EXAMPLE EVALUATION OF A PERMIT APPLICATION FOR A PROPOSED HAZARDOUS-WASTE LANDFILL IN EASTERN ADAMS COUNTY, COLORADO

Water-Resources Investigations Report 86-4131

Prepared in cooperation with the
U.S. ENVIRONMENTAL PROTECTION AGENCY

Figure 2.--Geologic section A-A'. (Trace of section shown in figure 4.)

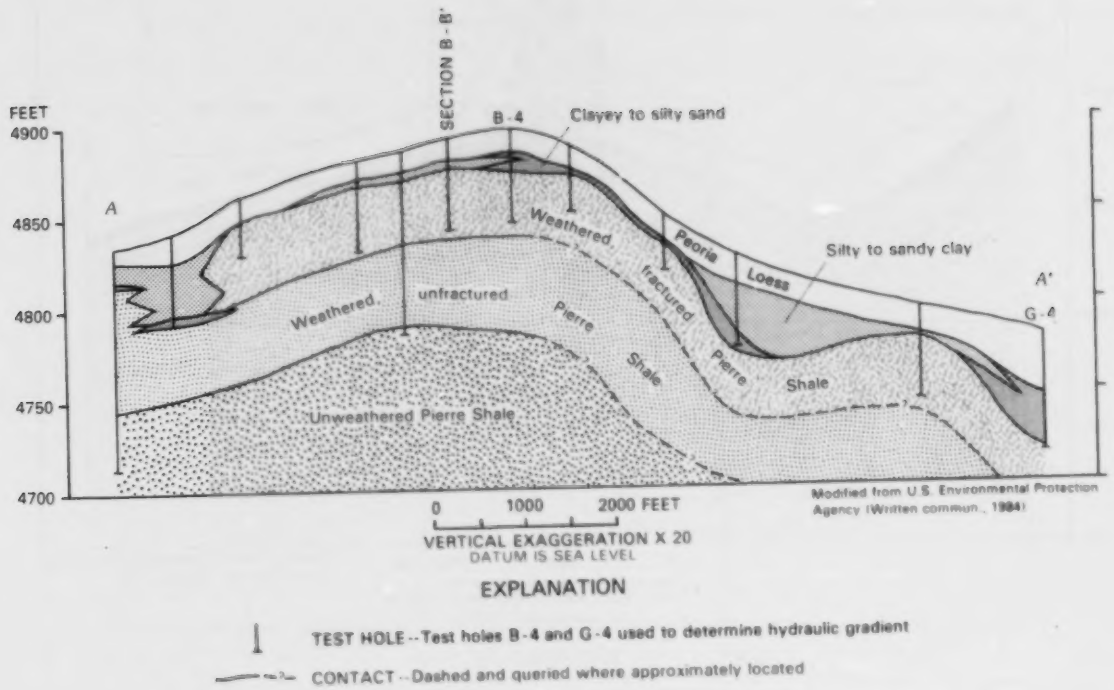
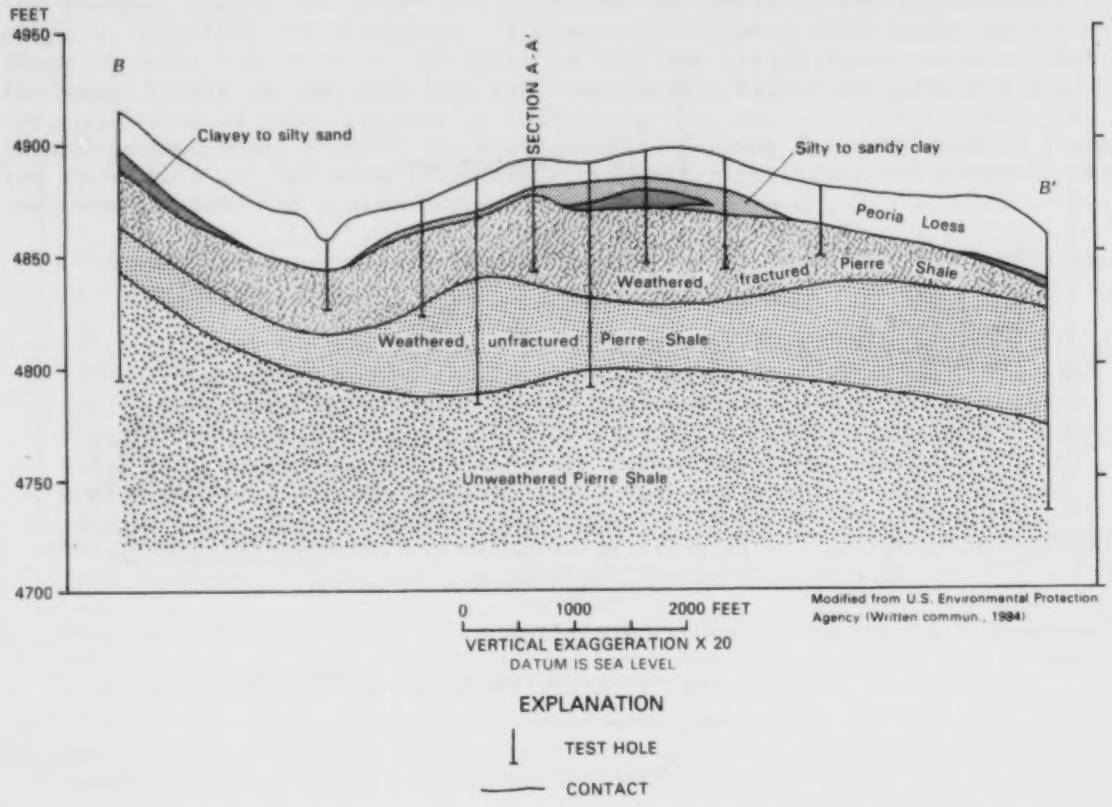
The degree of hydrologic connection of the sand zones encountered in drilling is critical to the site characterization. The sand is associated either with the eolian deposits or with the Pierre Shale. Sand associated with the eolian deposits would be found in zones parallel to the deposits, that is, approximately parallel to the land surface. Sand in unreworked beds of the Pierre would be found in zones parallel to the bedding of the Pierre. According to Sharps (1980), soft sandstone interbeds are predominant in the upper 400 ft of the Pierre. Kiteley (1978) described member A and members D and C, undivided, of the Pierre Shale as sandstone and clayey sandstone layers about 35 mi northwest of the site. These members are in stratigraphic positions that may be at the top of the Pierre Shale and its derivatives at the site. Because the extent of erosion of the Pierre is unknown, the exact stratigraphic position of the top of the Pierre at the site is unknown; however, the Pierre may be the source of the sand encountered in the holes drilled at the site. The applicant's interpretation (U.S. Environmental Protection Agency, written commun., 1984) shows the sand lenses oriented at an angle oblique to both the apparent bedding and the land surface.

The applicant's argument that the sand intervals represent several individual sand lenses is based on the fact that they occur at differing altitudes. However, if the sand zones encountered during drilling are continuous, the sand lens would dip at no more than 4° (about 7-percent slope), as shown in figures 2 and 3.

2. Representations of wells and sample holes shown on the geologic sections (included in the application) do not match the data supplied in the sample logs (also included in the application) in all cases.

Figure 4.--Distribution of sand within and adjacent to the site of the proposed landfill.

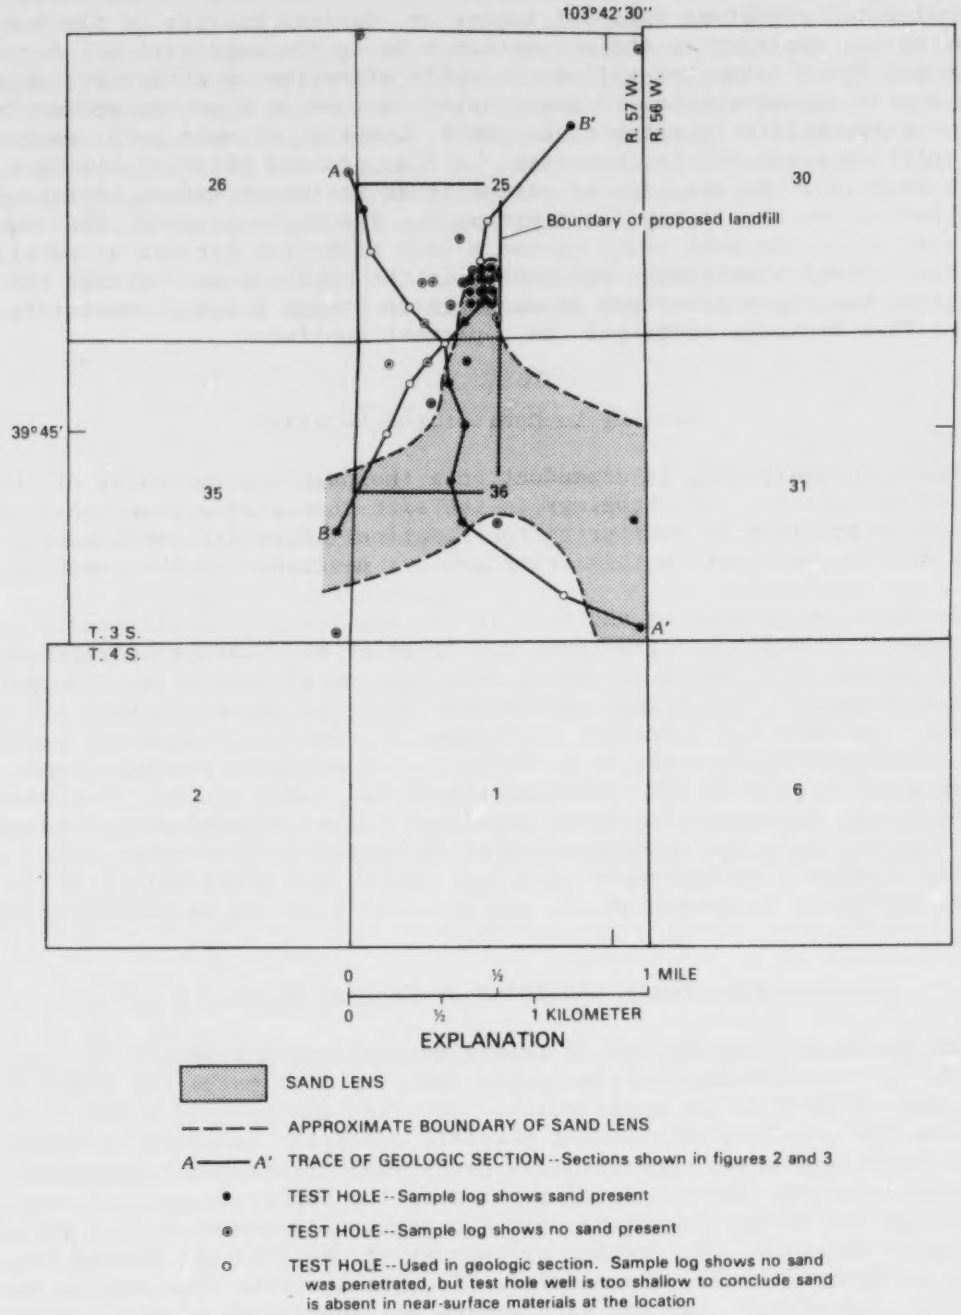
Sand deposits encountered in the southeastern part of the proposed site (fig. 4) are considered in this report to be continuous. Of the test holes that penetrated the sand, the three drilled at low-altitude sites penetrated water-saturated sand. The water levels in these test holes indicate a hydraulic gradient toward the southeast, approximately equal to the land-surface slope in magnitude and direction. A comparison between these water levels and those in wells completed in the upper part of the Pierre Shale indicate that the water levels in the sand lens are considerably higher and probably are representative of water perched on underlying clay and claystone zones. The permeable sand zones provide the most probable pathway for contaminants leaching from the site, but more core-sample and water-level data are necessary to adequately define the system hydraulics.

1. No water-level map was provided with the application. The water table, or tables where there are perched systems, need to be identified. Specifically, more water-level data for the sand lenses and for the unweathered Pierre Shale need to be collected to identify hydraulic gradients. Seasonal fluctuations in water-table altitudes need to be documented. The spring snowmelt period is of particular concern, because the saturated condition of the soil and the slow potential-evaporation rate may result in recharge to the aquifers and a water-table rise. In addition, contaminant transport likely would be greatest during this period.
